1R - 427-17

From: Katie Jones [kjones@riceswd.com]
Sent: Friday, February 18, 2011 1:18 PM
To: Hansen, Edward J., EMNRD
Cc: Hack Conder; lpg@texerra.com
Subject: EME Jct. K-33-1 (AP-60) and Sarah Phillips EOL (1R427-17) Termination Request Addendum
Attachments: EME Jct. K-33-1 and Sarah Phillips Termination Request Addendum - Figure 7.pdf

RE: **Groundwater Monitoring Report & Remediation Termination Request**
Rice Operating Company EME SWD System
Sarah Phillips Jct – NMOCD Case Number 1R-427-17
K-33-1 Jct - NMOCD AP-60

Figure 7a – Measured and interpolated groundwater chloride concentrations: Average 2007 values. [Note that the lateral plume boundaries were assumed to equal a baseline groundwater chloride concentration of 200 mg/kg].

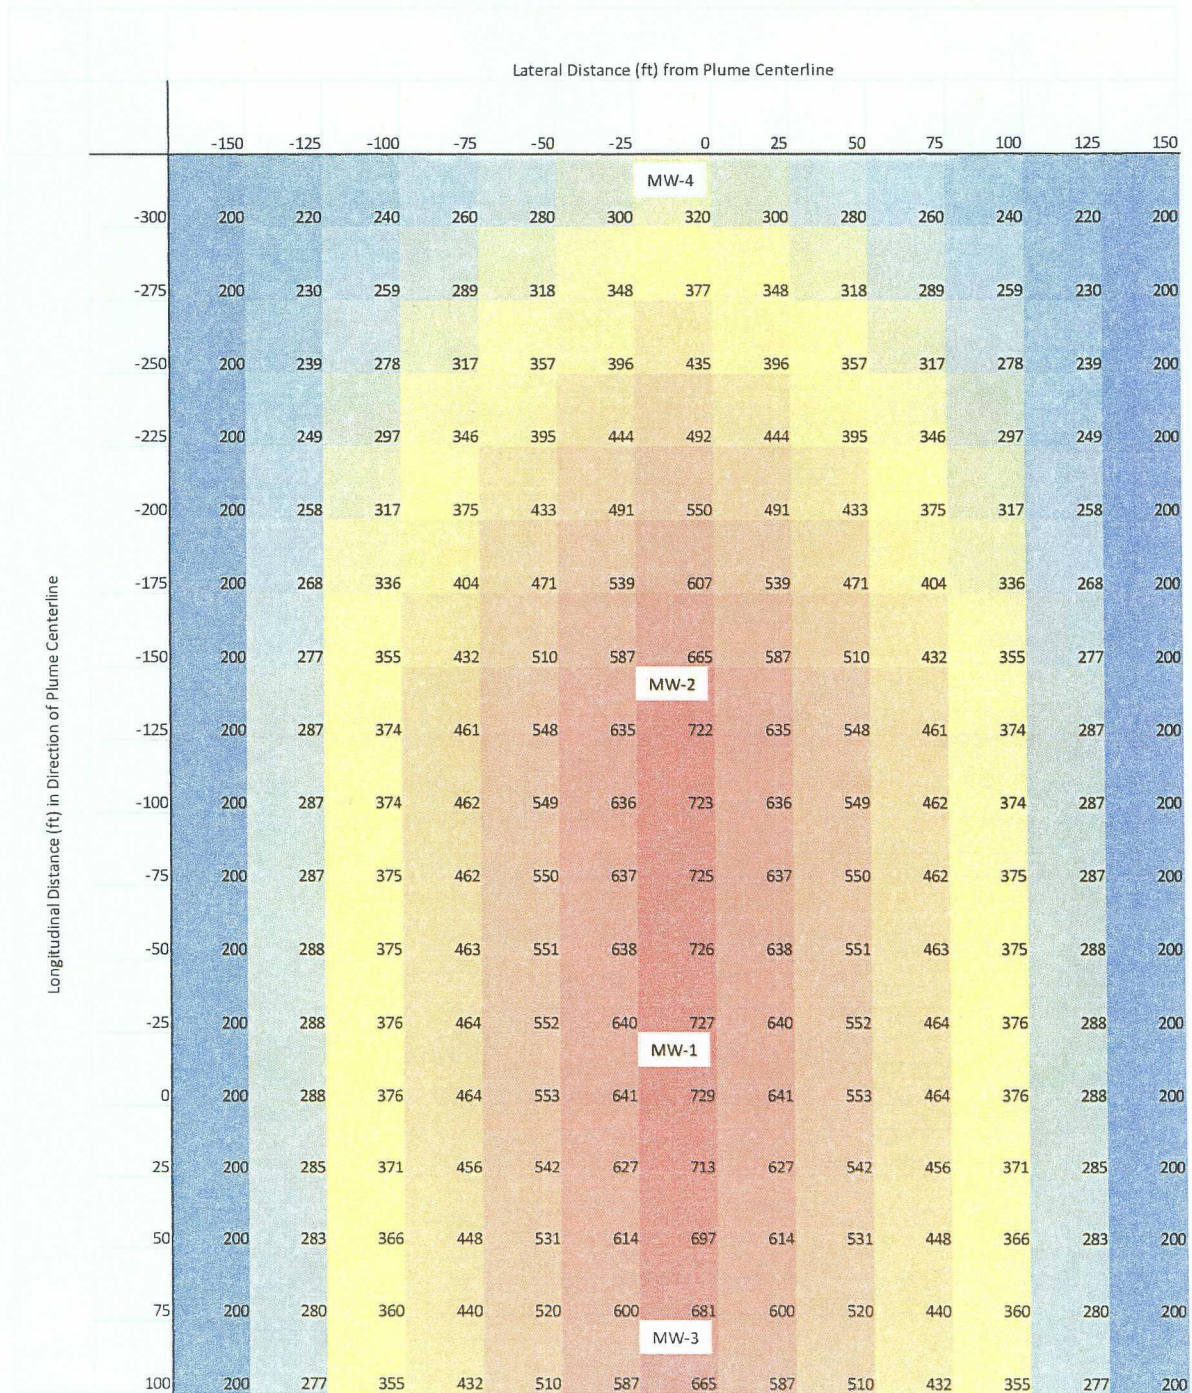
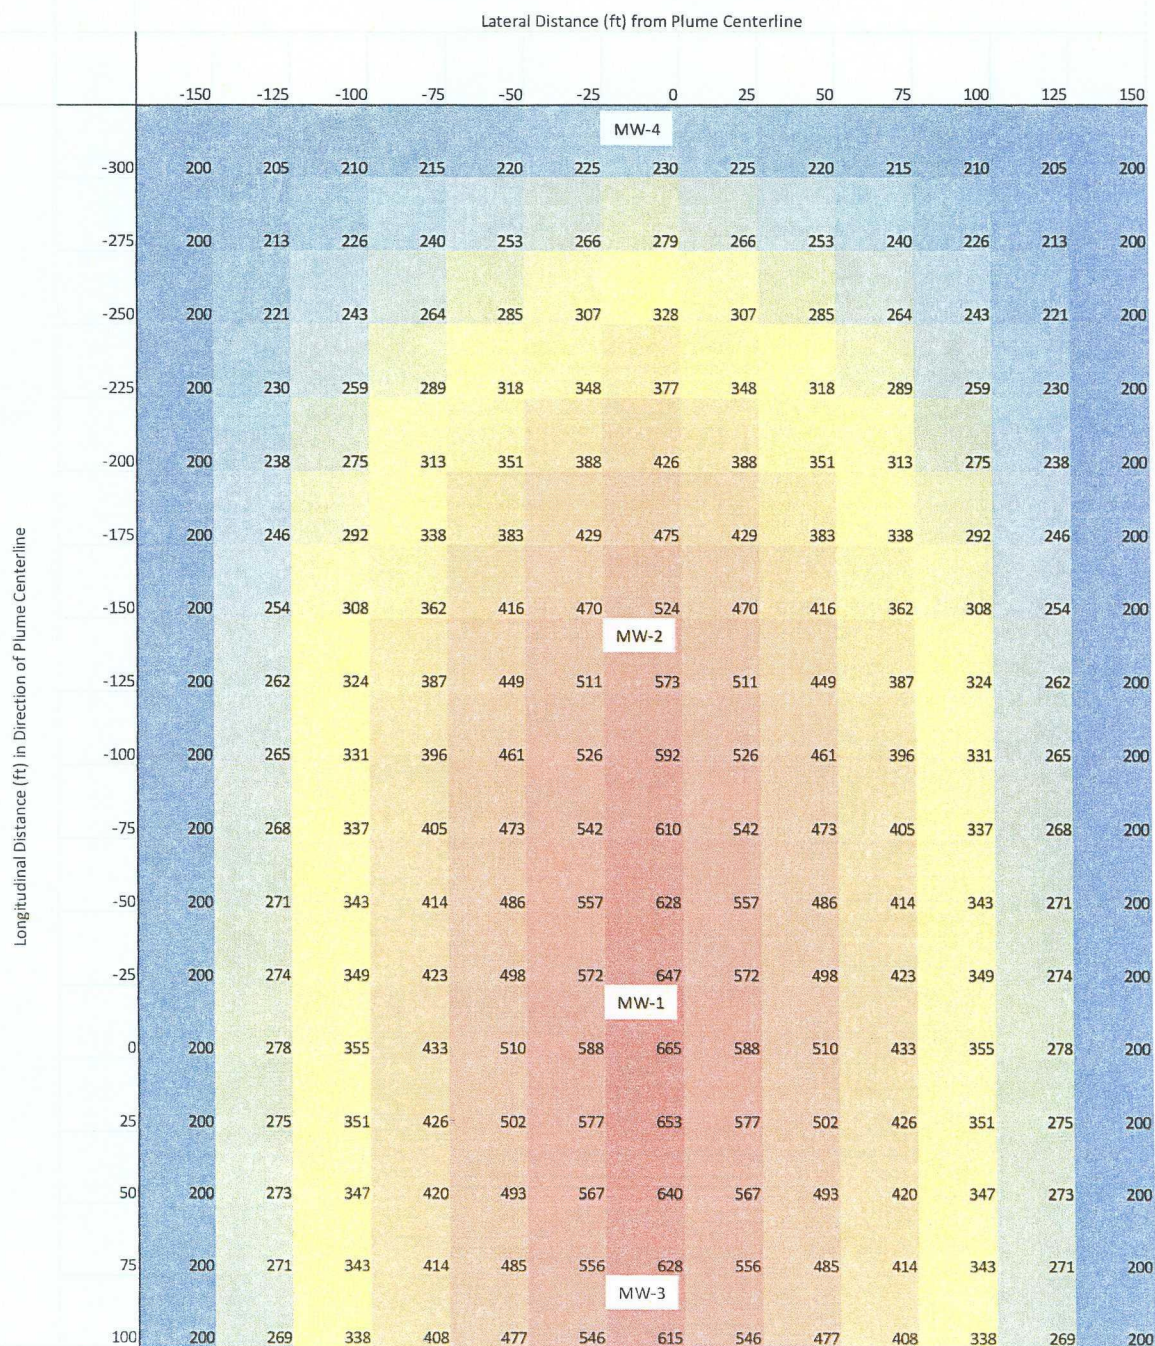
Attached is a revised Figure 7 to replace Figures 7a and 7b (pages 10 and 11) of the EME Jct. K-33-1 (AP-60) and Sarah Phillips EOL (1R427-17) Termination Request. ROC also requests to plug and abandon MW-1, MW-2, MW-3, and MW-4 located at Jct. K-33-1 and MW-1 located at Sarah Phillips EOL using a cement grout with 1 to 3% bentonite and a 3 foot cap of cement. If you have any questions or require any additional information, please contact Hack Conder at (575)631-6432 or myself at (575)393-9174.

Figure 7 – Average annual groundwater chloride concentrations (mg/kg) for 2007 (left) and 2010 (right). These data indicate that the source of the moderately elevated groundwater chloride concentrations observed near the EME K-33-1 and Sarah Phillips junction boxes in 2007 is from the regional chloride plume known to exist to the west of these sites. The data also indicate that chloride concentrations are gradually diminishing over time due to natural attenuation. [The regional direction of groundwater flow is from NW to SE. North is “up”. Maps are approximations to actual scale].
